ADDENDUM NO. 2

Kau Water System Improvements – Phase 1

IFB No.: IFB-20-HHL-019

DWG. NO.
C-11
 SHEET 13 OF 54

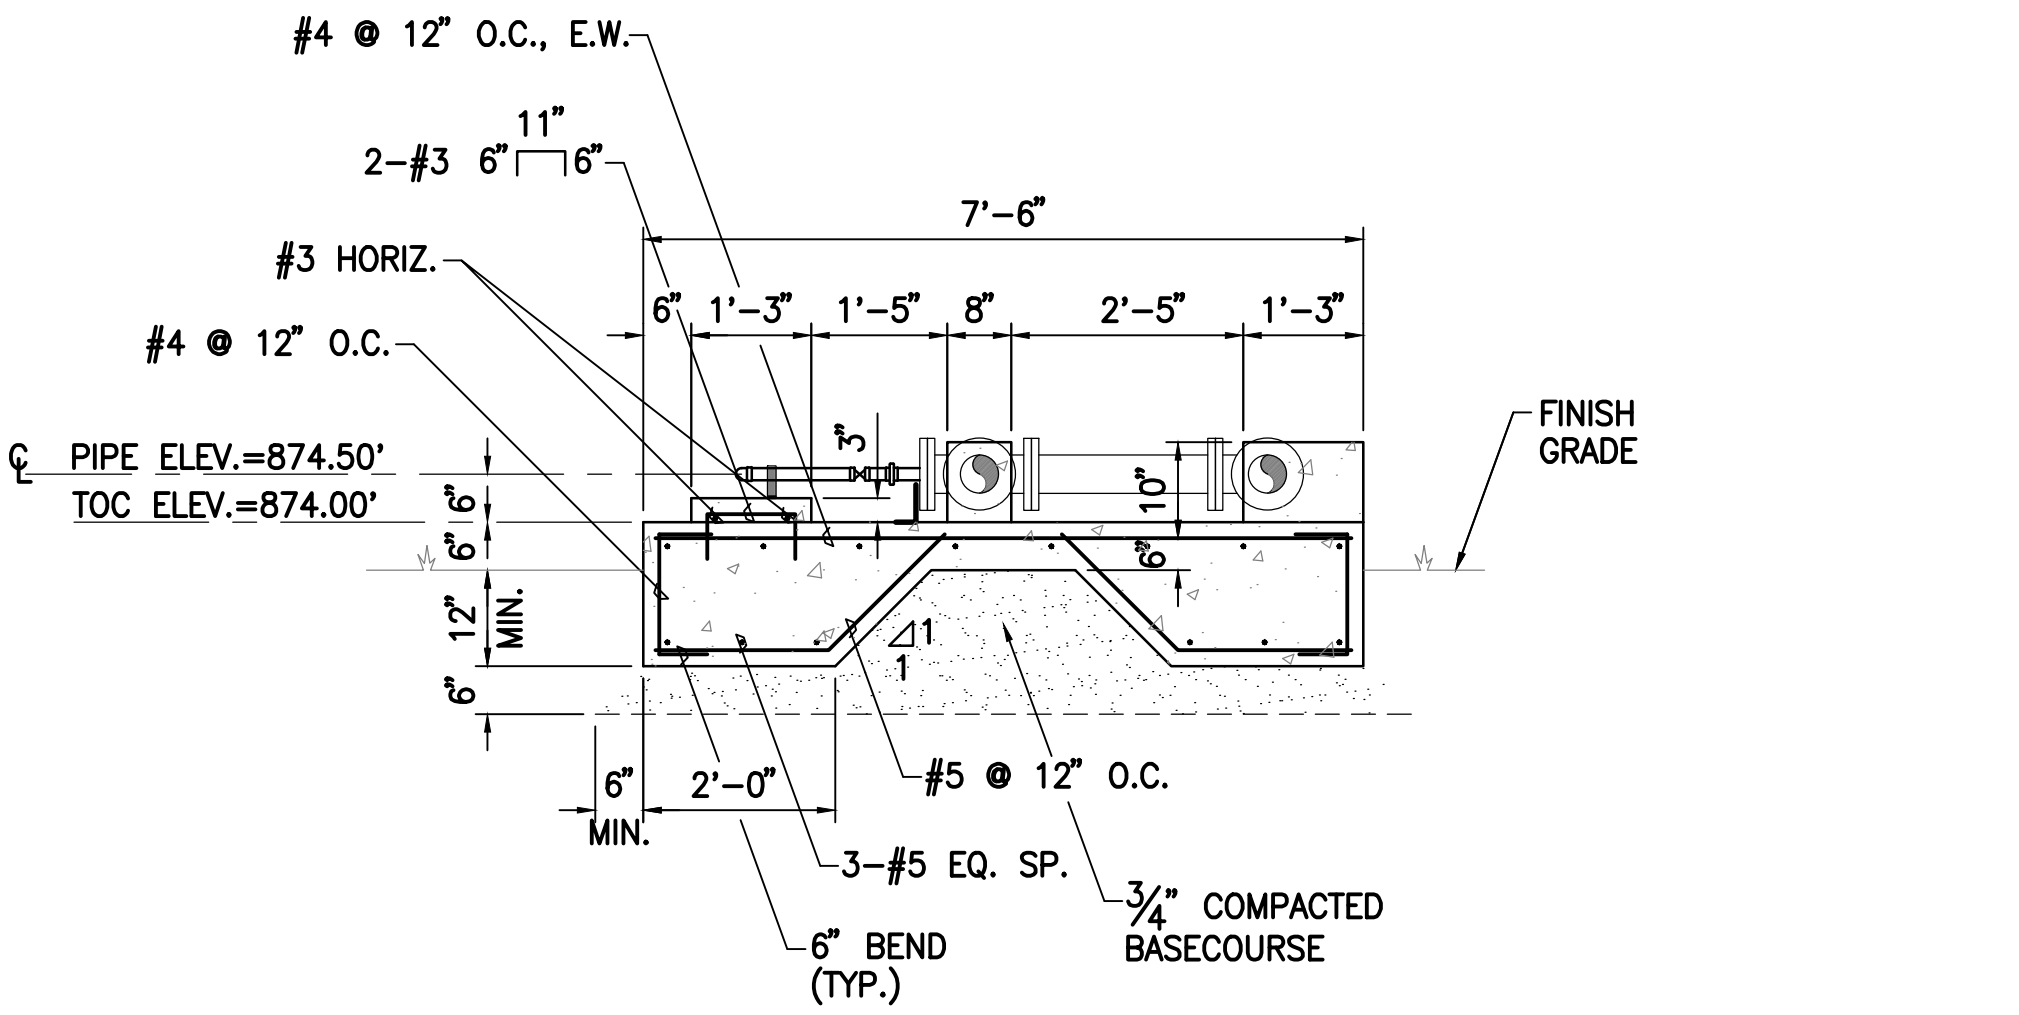
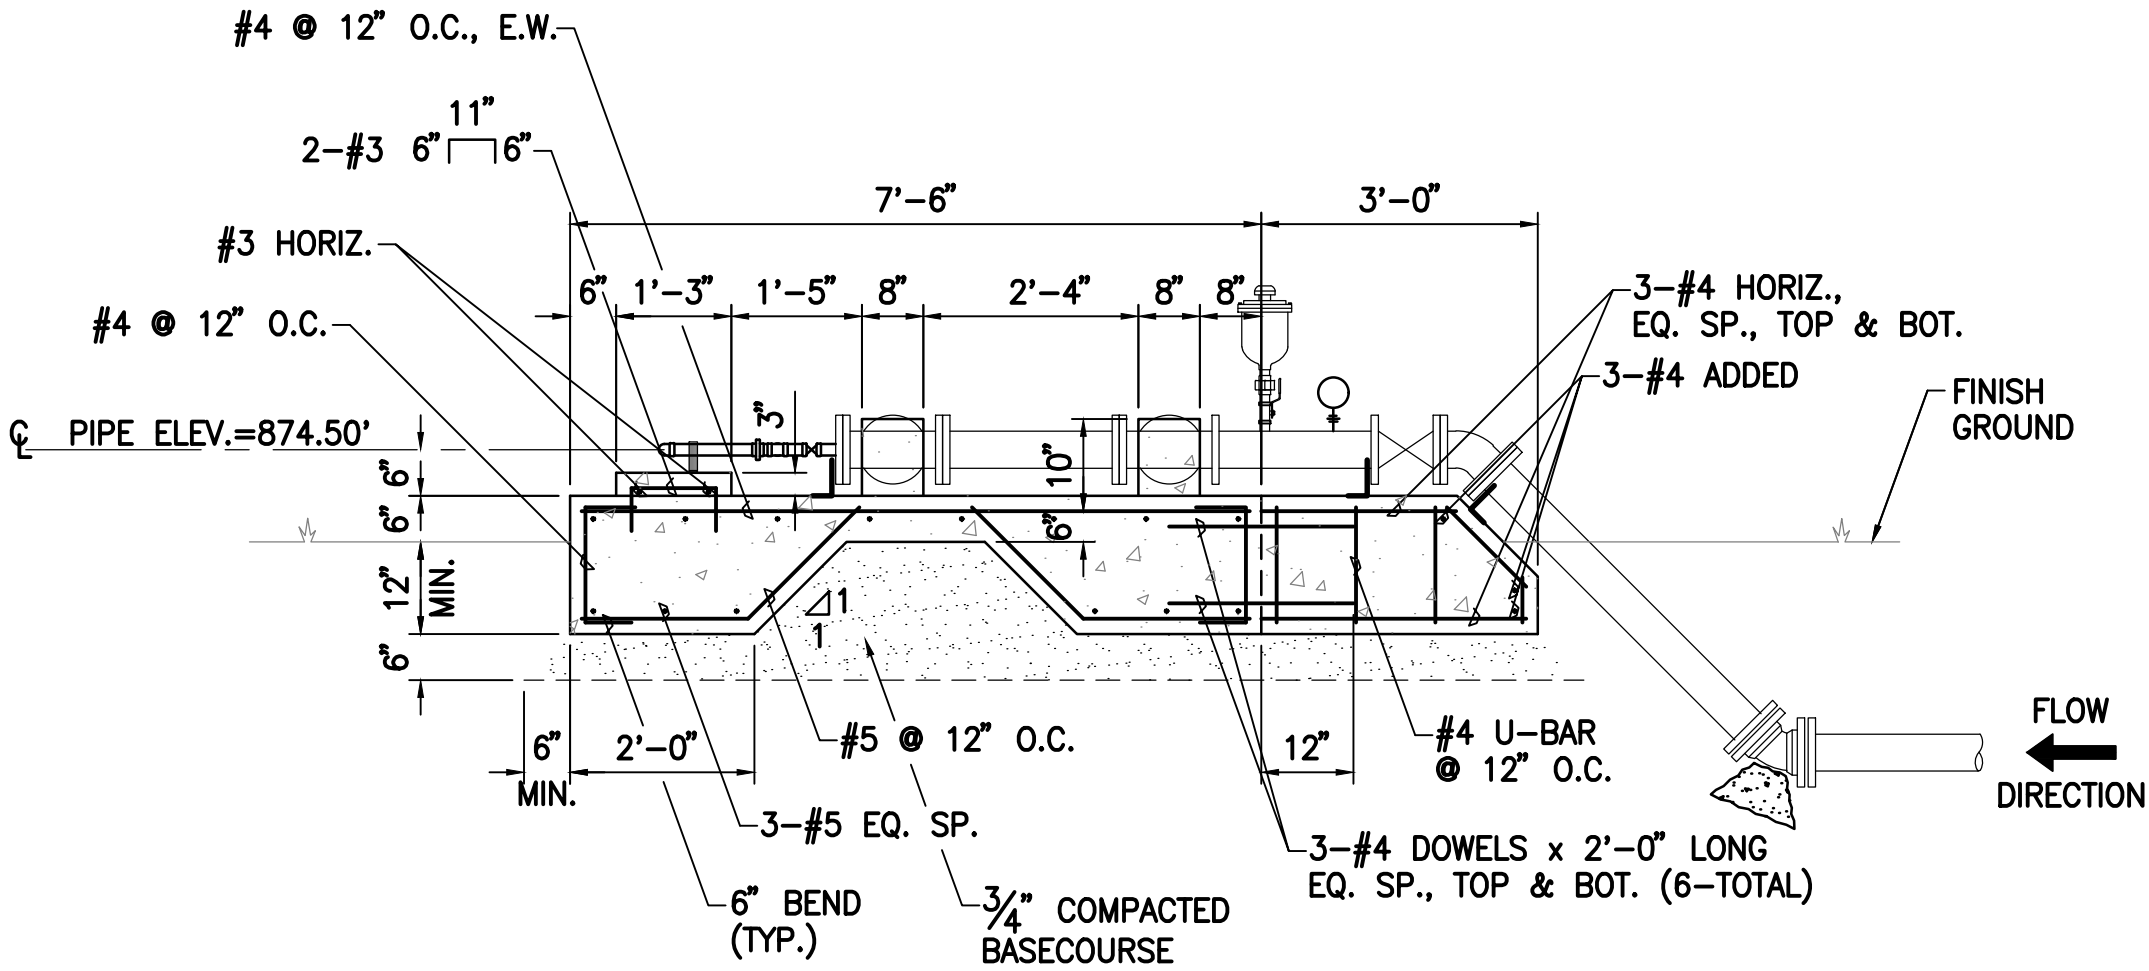
7. PLANS: Drawing No. C-11 - Revisions include relocating the concrete support pedestal for the deleted 1-1/2 – inch combination pressure relief and solenoid control valve to the downsized 1-1/2 – inch combination pressure relief and remote control valve.

DWG. NO.
C-12
SHEET 14 OF 54

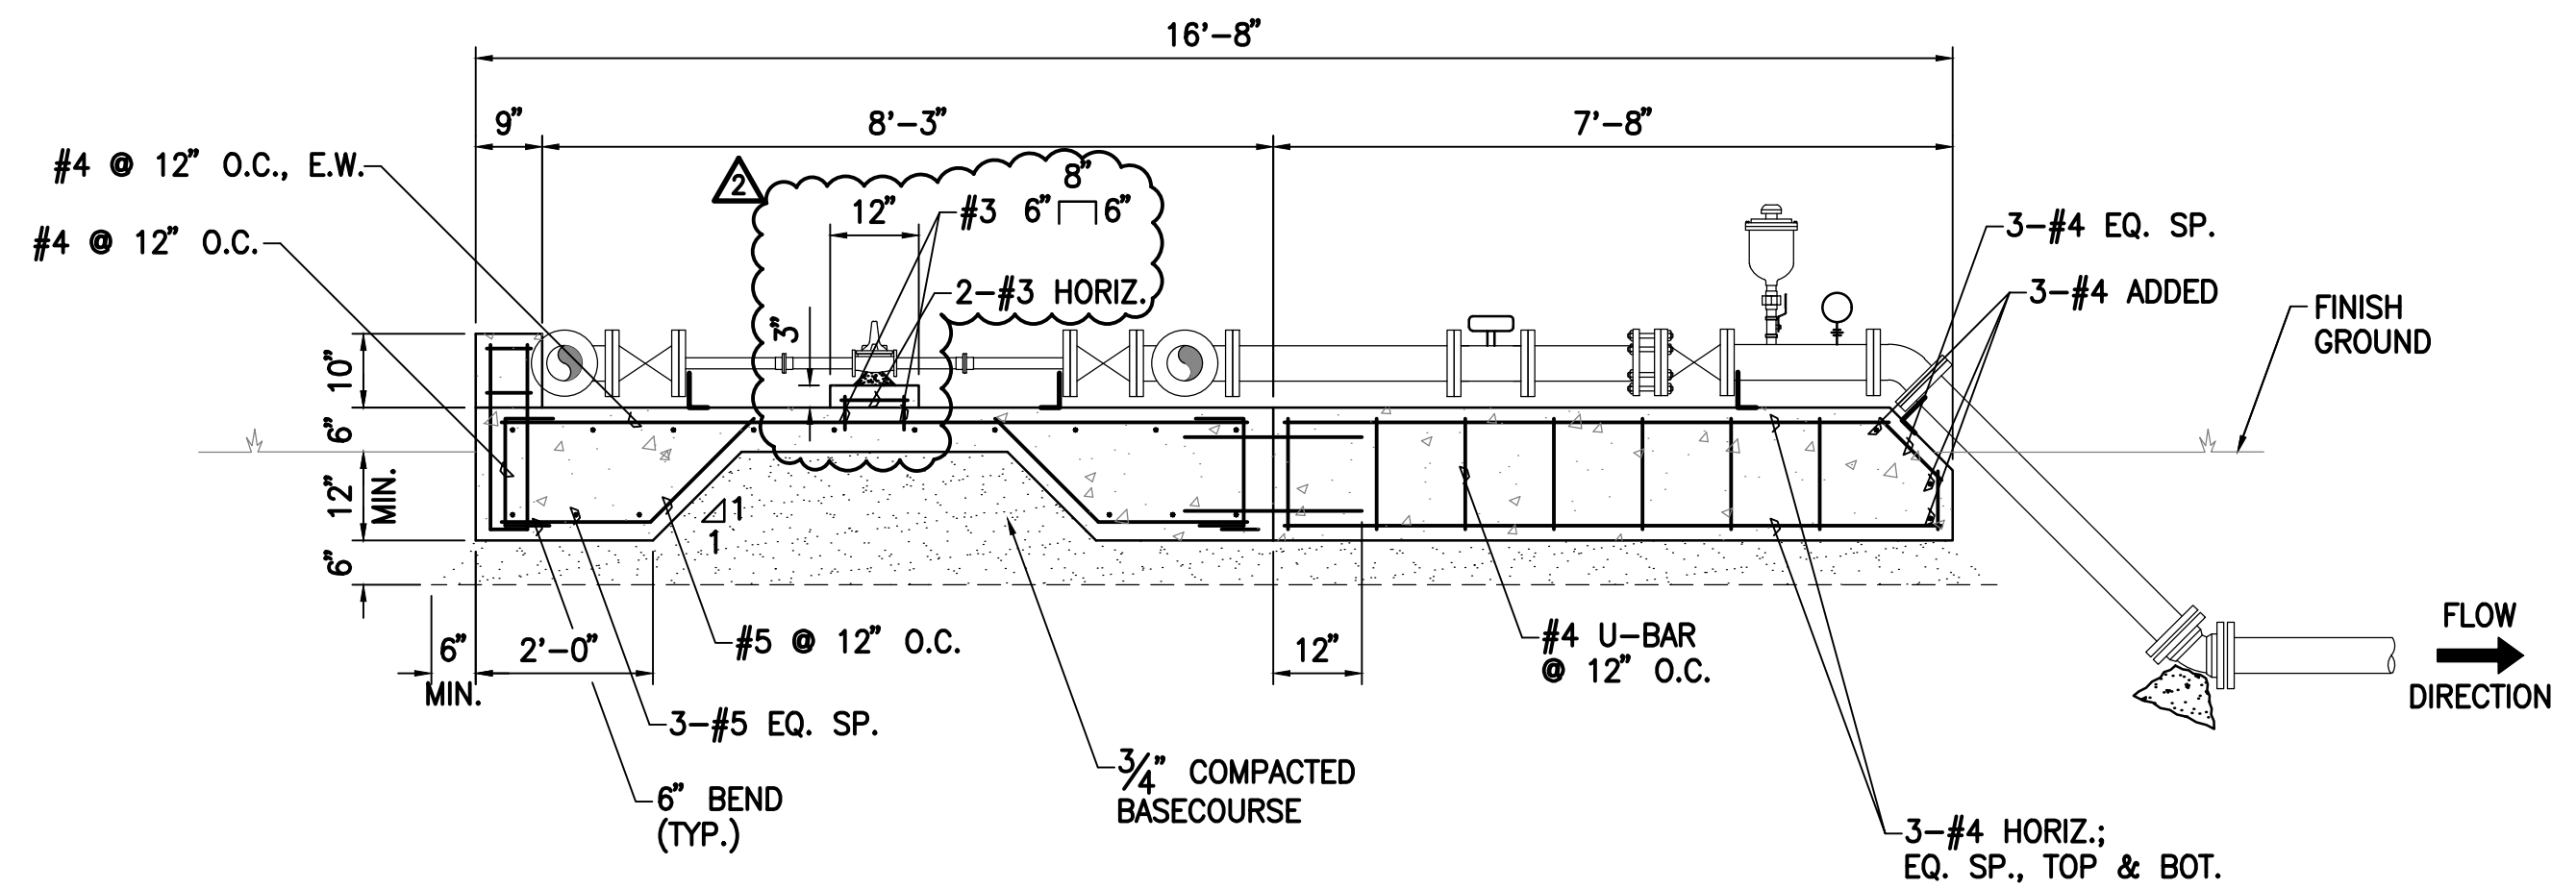
8. PLANS: Drawing No. C-12 - Revisions include revising the sectional views of the reservoir influent control valve station concrete foundation to suit its revisions described for Drawing No. C-11 above; delete Section F.
